MOBILE COMMUNITY CORRECTIONS

SUBDIVISION, LOT 1

APPLICATION NUMBER 2 DATE April 20, 2017

DETAIL SITE PLAN

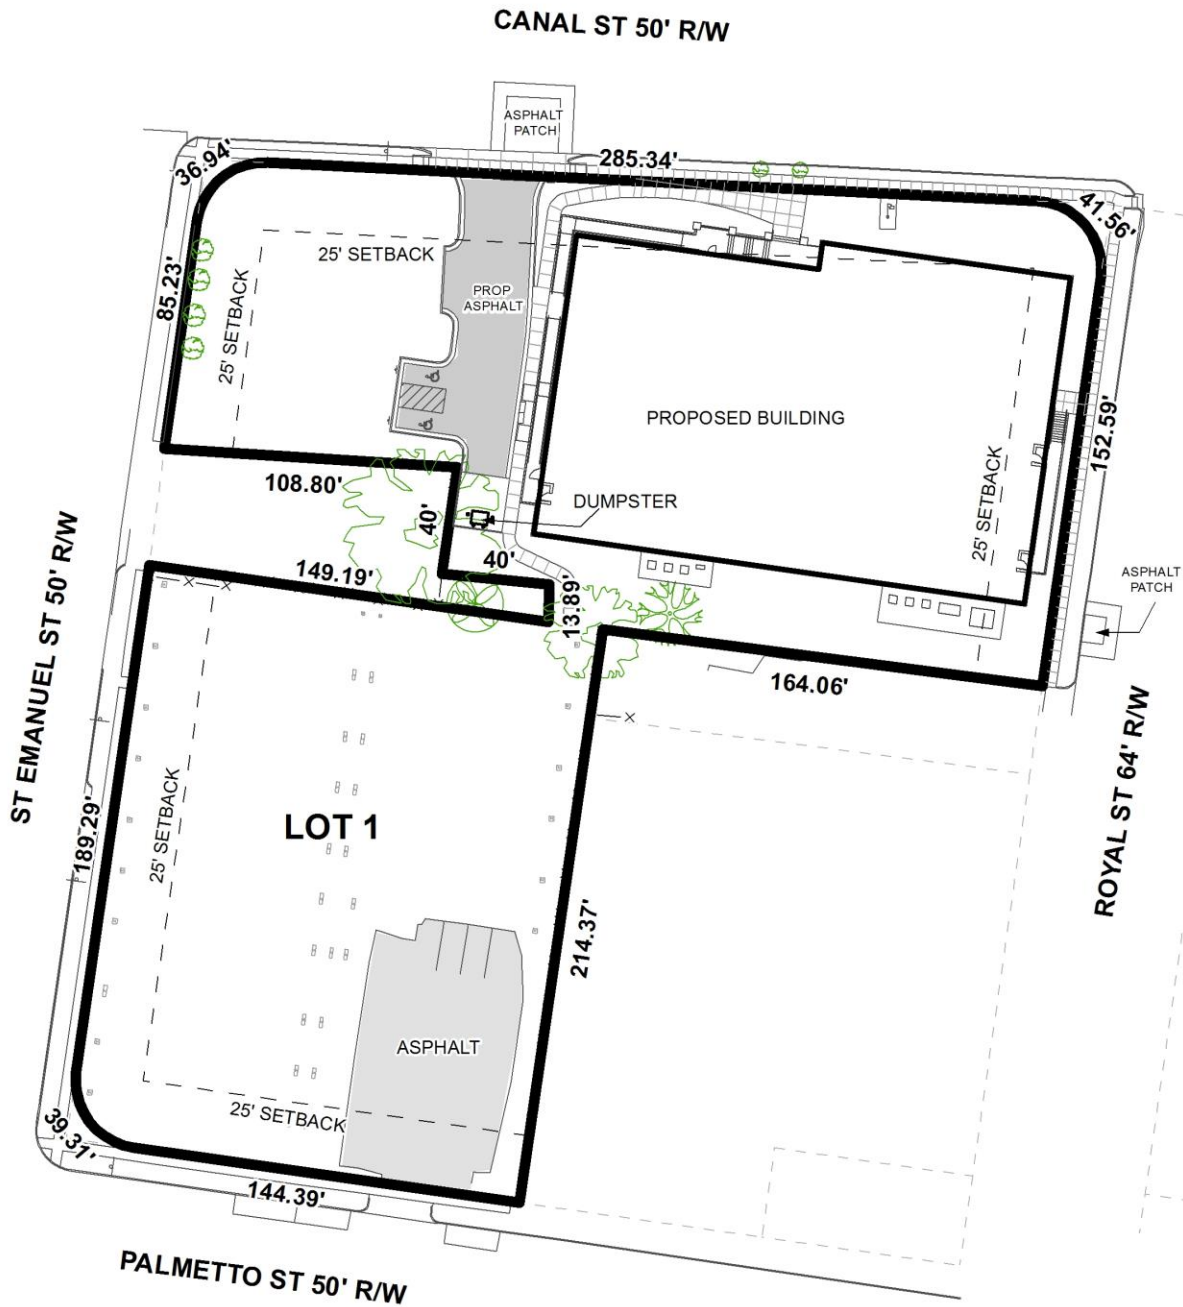
The plat indicates a 5’ alley off Canal Street which is proposed to be vacated and incorporated into the final lot. The Vacation process for this alley should be completed prior to signing the Final Plat.

The proposed lot meets the minimum size requirement of the Subdivision Regulations. The plat labels the lot with its size in both square feet and acres. However, as corner radius dedications are required, the label should be revised to reflect the lot area after dedications or a table should be furnished on the Final Plat providing the same information.

It appears that there may not currently be a public sidewalk along the South Royal Street frontage. It should be noted that the Subdivision triggers the sidewalk requirement along all street frontages.

A site plan for the proposed building on the site was submitted indicating encroachments into the standard 25' minimum building setback lines along South Royal Street and Canal Street. As other encroachments are typical within the area, staff has determined that the plat should be revised to indicate the minimum building setback lines along those frontages to be along the proposed building facade lines. The standard 25' minimum building setback lines should remain along St. Emanuel Street and Palmetto Street.

Staff has determined that, due to pending revisions to the Major Street Plan, additional right-of-way will no longer be requested along South Royal Street. Therefore, no dedication should be required along that street frontage.

- 1) revision of the plat to indicate the minimum building setback line along South Royal Street and Canal Street as being along the proposed building facade lines;*

- 2) retention of the standard 25' minimum building setback line along St. Emanuel Street and Palmetto Street;*
- 3) revision of the plat to provide a 25' corner radius dedication at the intersections of Canal Street and South Royal Street, Canal Street and St. Emanuel Street, and St. Emanuel Street and Palmetto Street;*

- 4) completion of the Vacation process for the 5' alley off Canal Street prior to signing the Final Plat;*
- 5) revision of the plat to label the lot area after corner radius dedications or the furnishing of a table on the Final Plat providing the same information;*

- 6) installation of a sidewalk along all street frontages if not present, or the submission and approval of a Sidewalk Waiver application for each lot;*
